Subject: Duane Arnold Energy Center  
Docket No: 50-331  
Op. License No: DPR-49  
Results of Inspection of Stainless Steel  
Piping at the Duane Arnold Energy Center  
Reference: Letter, R.W. McGaughy (Iowa Electric) to  
H.R. Denton, dated May 3, 1985 (NG-85-1901);  
Letter, R.W. McGaughy (Iowa Electric) to  
H.R. Denton, dated May 24, 1985 (NG-85-2480)  
File: B-31c, SpF-118, A-107a

ADDITIONAL INFORMATION  
REGARDING UT EXAMINATIONS

NRC REQUEST FOR ADDITIONAL INFORMATION CONCERNING UT RESULTS OF  
RECIRCULATION SYSTEM WELDS

WELD OVERLAY DESIGN AND ANALYSIS  
FOR THE INDICATIONS IN THE DUANE ARNOLD  
RECIRCULATION AND RESIDUAL HEAT REMOVAL SYSTEMS

Figure 2. Weld Overlay Design For Recirculation Risers

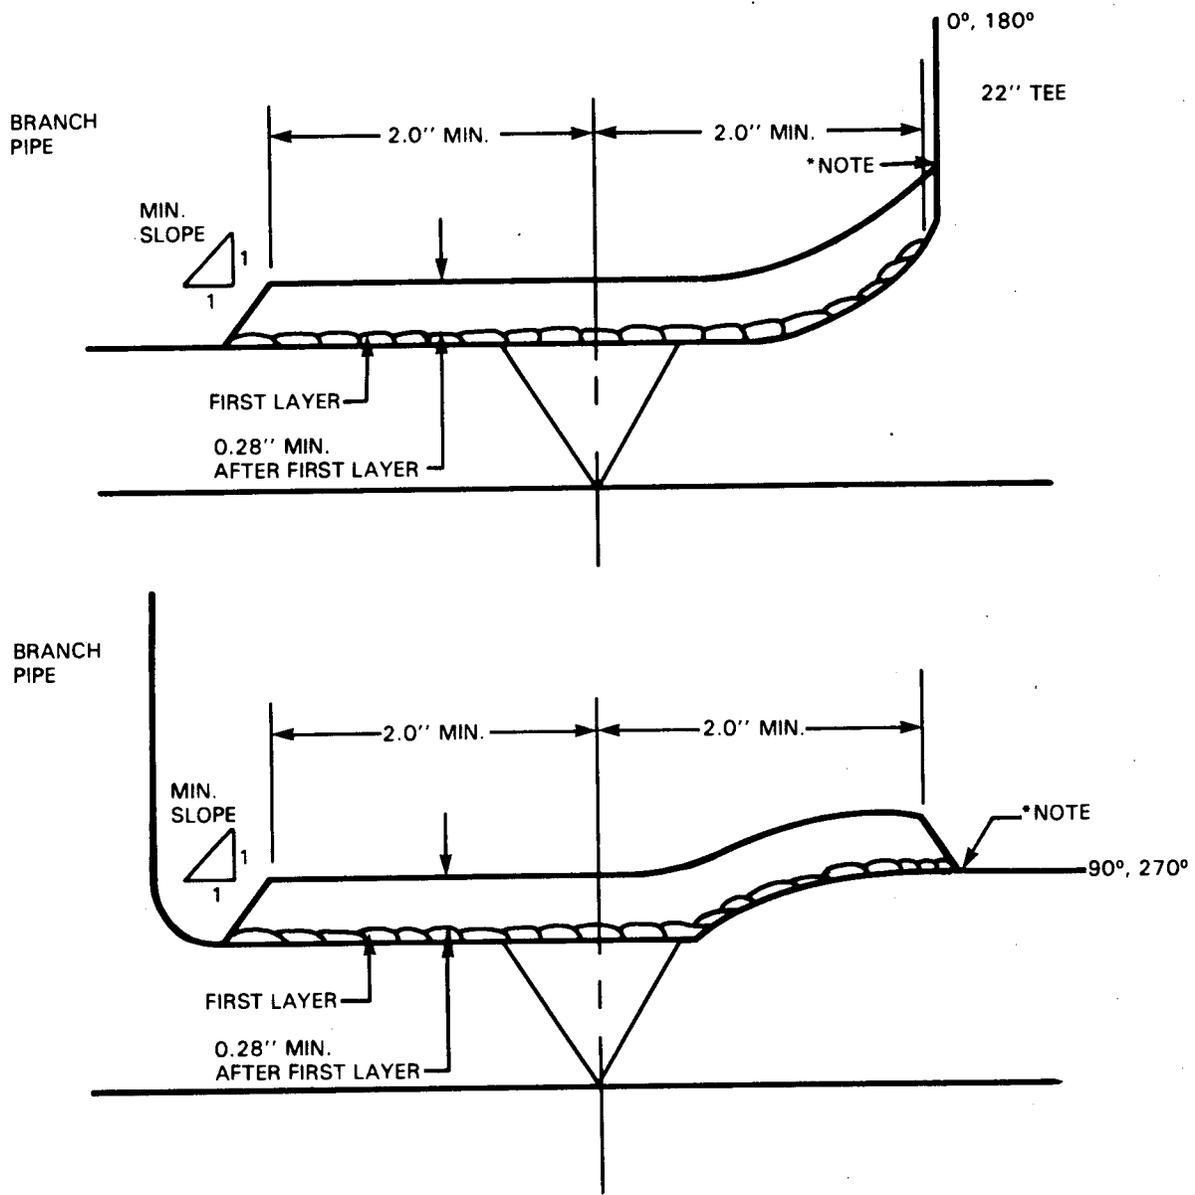
In addition to the above requested information, it has been determined that the weld overlay design report for the J4-J4A welds (submitted May 24, 1985) must be resubmitted to reflect revised minimum overlay thicknesses.

Figure 1 through 3 show the weld overlay design for all cracked locations. The weld overlay thickness of 0.215" for the J4/J4A welds was selected to provide an overlay suitable for any riser location since examinations were still in progress. Subsequently, detailed wall thickness data was obtained prior to weld overlay. The updated thickness data and the design stresses at each riser were used to calculate specific weld overlay thicknesses for each riser J4/J4A weld location.

TABLE 2 Final Weld Overlay Thickness Dimensions

<u>WELD ID</u>	<u>MINIMUM WELD OVERLAY THICKNESS (in.)</u>
RRA-J4/J4A	0.190 after first layer
RRB-J4/J4A	0.170 " "
RRD-J4/J4A	0.185 " "
RRE-J4/J4A	0.185 " "
RRF-J4/J4A	0.165 " "
RRG-J4/J4A	0.165 " "
RRH-J4/J4A	0.190 " "
RHB-J1	0.280 " "
RRD-J7	0.190 total, two layers after first layer
